SPRINGHILL-LOUISELLE SUBDIVISION, **RESUBDIVISION OF LOT 1**

APPLICATION NUMBER 3 DATE April 21, 2016
 APPLICANT Springhill-Louiselle Subdivision, Resubdivision of Lot 1
 REQUEST Subdivision

DETAIL SITE PLAN

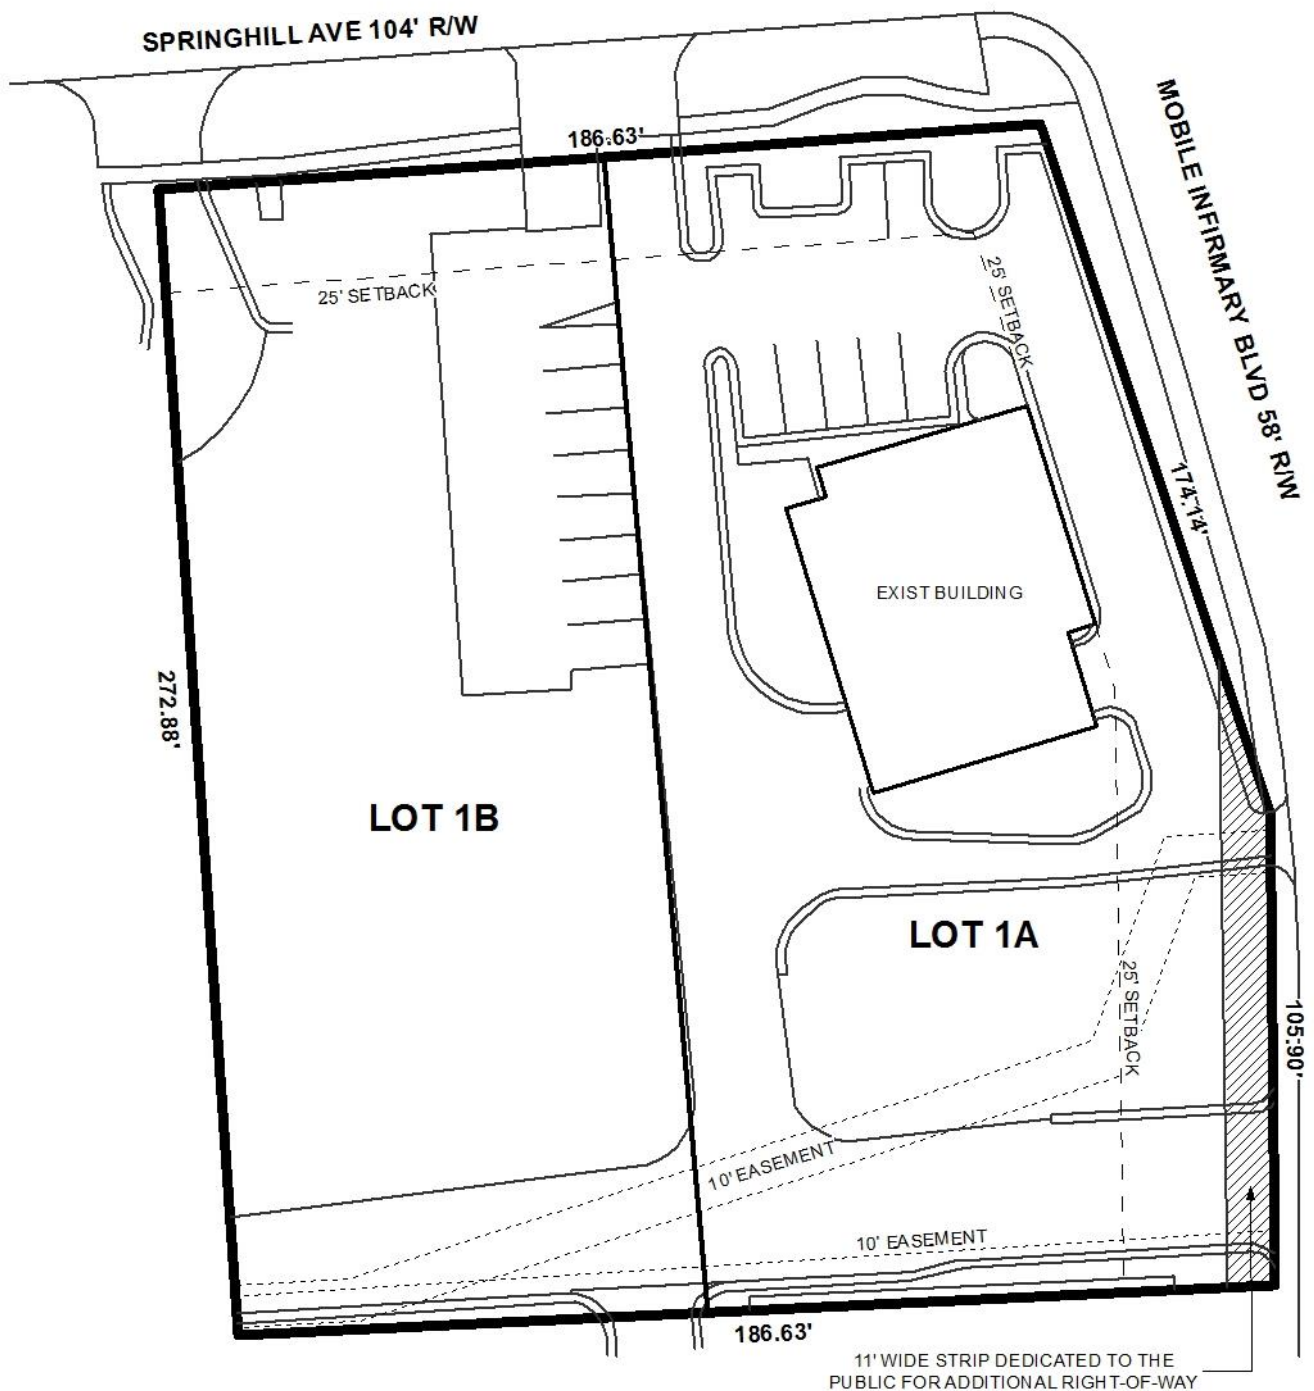
The site has frontage on both Springhill Avenue and Mobile Infirmary Boulevard. Mobile Infirmary Boulevard is a minor street, provided with curb and gutter, and depicted with existing adequate right-of-way of 58 feet, however, the plat shows the dedication of an additional 11 feet of right-of-way along a portion of the Mobile Infirmary Boulevard frontage: right-of-way dedication along Mobile Infirmary Boulevard was not required when the original lot was created in 2003, thus it is unclear why dedication is being shown for the application at hand. Spring Hill Avenue is a major street and requires a 100 foot right-of-way, and a 104 foot wide right-of-way is depicted on the plat. If dedication is not required, the plat should be revised to remove information regarding dedication.

Access management is a concern, as Spring Hill Avenue is a major street, and the site is located at an intersection. The site has existing curb-cuts to both Spring Hill Avenue and Mobile Infirmary Boulevard. One of the existing curb-cuts to Spring Hill Avenue is shared with the adjacent lot to the West, and as proposed, Lots 1A and 1B would share the other existing curb-cut to Spring Hill Avenue. Of the existing curb-cuts to Mobile Infirmary Boulevard, the Southern-most curb-cut serves an existing driveway that connects across proposed Lot 1A to Lot 1B and the abutting lot to the West, while the second curb-cut appears to serve only proposed Lot 1A. The PUD that will be heard at the May 5, 2016 meeting includes a site plan depicting the redevelopment of Lot 1A, and it appears that one of the existing curb-cuts to Mobile

Infirmary Boulevard will be removed. Therefore, both Lots 1A and 1B should be limited to their existing curb-cuts to Spring Hill Avenue, and Lot 1A should be additionally limited to one curb-cut to Mobile Infirmary Boulevard, with any changes to the size, location and design to be reflected in any approved PUD site plan, and to be approved by ALDOT and Traffic Engineering and conform to AASHTO standards.

There appears to be a drainage easement located on the site. A note should be placed on the Final Plat stating no structures shall be constructed or placed within any easements.

- 1) retention of the 25' minimum building setback line on the Final Plat;
- 2) revision of the plat to remove any dedication of right-of-way, if dedication is not required;

- 3) revision of the lot sizes in square feet and acres, as necessary for condition number 2;
- 4) placement of a note on the Final Plat stating no structures shall be constructed or placed in any easements;

- 5) placement of a note on the Final Plat stating that both Lots 1A and 1B are limited to their existing curb-cuts to Spring Hill Avenue, and Lot 1A should be additionally limited to one curb-cut to Mobile Infirmary Boulevard, with any changes to the size, location and design to be reflected in any approved PUD site plan, and to be approved by ALDOT and Traffic Engineering and conform to AASHTO standards;
